1087, 1091 and 1095 Leslie Street - Zoning By-law Amendment and Draft Plan of Subdivision Applications - Request for Direction Report

Date:	June 6, 2016
To:	North York Community Council
From:	Director, Community Planning, North York District
Wards:	Ward 25 – Don Valley West
Reference Number:	15 108593 NNY 25 OZ and 15 108578 NNY 25 SB

Attachment 3: Master Plan

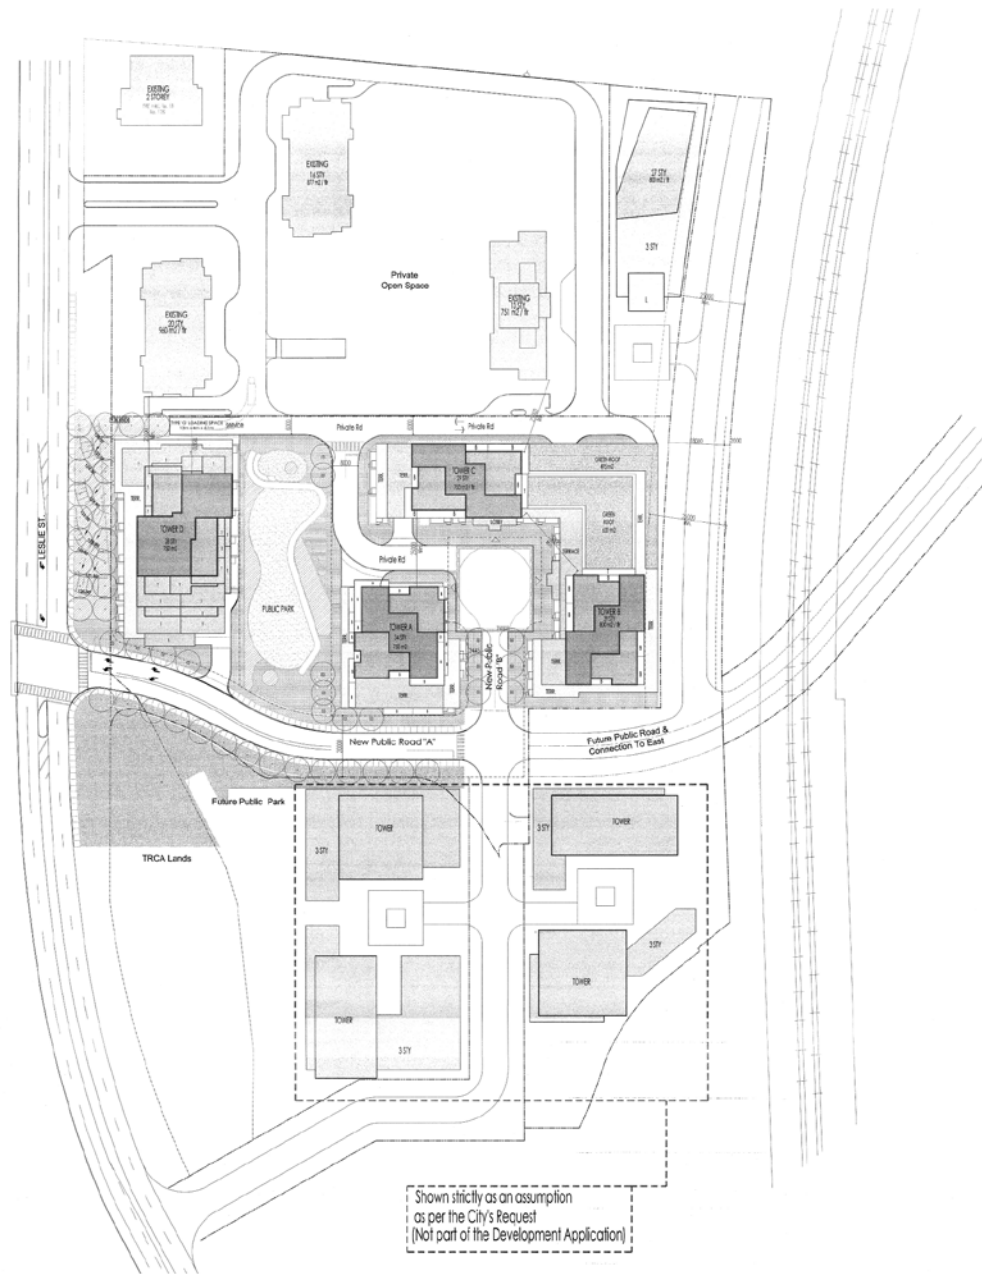
Staff also requested the applicant submit a concept plan or master plan for the remaining car dealership lands to the south of their development and the car parking garage at the northeast end of the site. The applicant submitted a conceptual master plan that illustrates a 27-storey building with a floor plate of 800 m² and a 3-storey podium building on the car parking garage site. The master plan estimates that this site would have 285 dwelling units, 348 parking spaces and a density of 4.54. The applicant's master plan also illustrates new public Street B continuing south into the car dealership lands and then turning westwards and connecting to Leslie Street at the south end just north of Eglinton Avenue East. The master plan illustrates 4 additional towers on top of 3-storey podiums fronting on to the extension of Street B. However, the plan provides no details on number of storeys, floor plates, unit count or density (see Attachment 3: Master Plan).

- Submit a revised master plan which provides for an appropriate network of public roads, open space, transition from Eglinton Avenue East to the Carrington development site, and a massing strategy.

Attachment 4: Phasing Plan

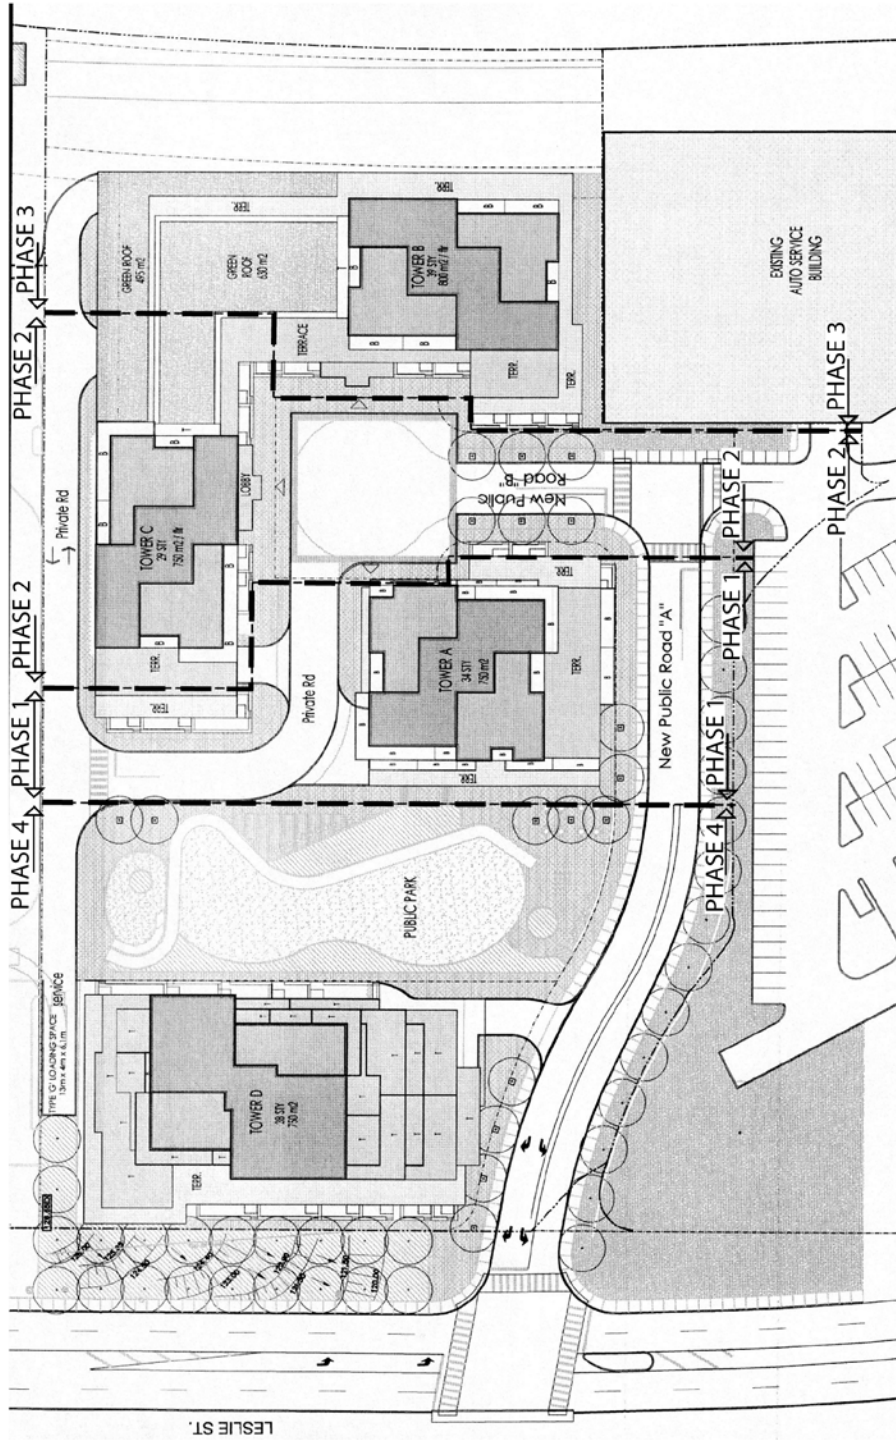
The applicant is proposing to develop the subject site in 4 phases. The first phase of the development would consist of tower A, the second phase of development would consist of tower C, the third phase of development would consist of tower B and the final phase of development would consist of tower D and the proposed public park. The applicant's phasing plan illustrates phasing lines through public Street A, however, it is unclear if the applicant intends to phase public Street A (see Phasing Plan – Attachment 4).

Attachment 5: Draft Plan of Subdivision

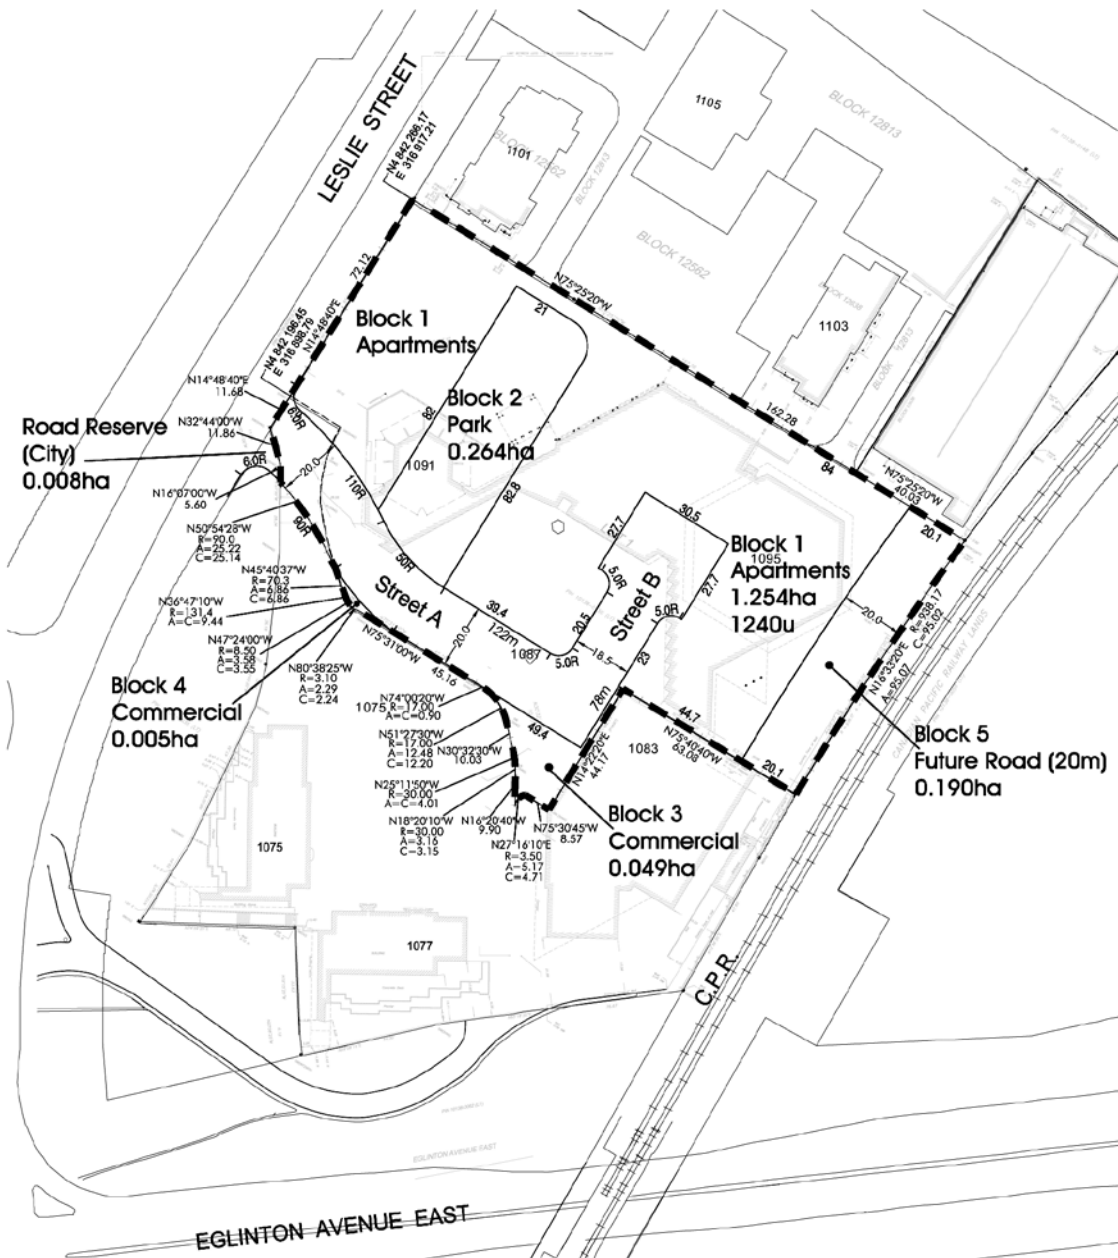
The site has been organized with access being provided from a new east-west 20 metre wide public street from Leslie Street (new public Street A). The new public street would then turn north at its eastern most end having a width of 18.5 metres (new public Street B) and terminate in a cul-de-sac between towers A, B and C. Streets A and B provide public street frontage for the proposed towers and the new public park central to the site.

In order to facilitate the applicant's proposed Street A in the location and configuration as shown on the draft plan of subdivision, the applicant has included a City owned road reserve of 0.008 ha as part of their proposal. The applicant requires this City land to complete the access point to their development site. Without it, the proposed Street A and access at Leslie Street would need to be reconfigured shifting a portion of Street A north.

The applicant's proposal would need to be further refined to ensure that the public streets can be conveyed or secured as part of the current phase of development and application instead of future development phases and applications. In order to complete the proposed public street network and provide for a connection over/under the railway tracks to the Celestica lands, the car wash building on the car dealership lands would ultimately need to be demolished. Staff wants to ensure that an appropriate public street network is established to support the current phase of development and not preclude future development phases and the ultimate comprehensive build out of these lands.

owned lands outside of the subject property and is the area generally shown as the City road reserve on the draft plan of subdivision (Attachment 5).
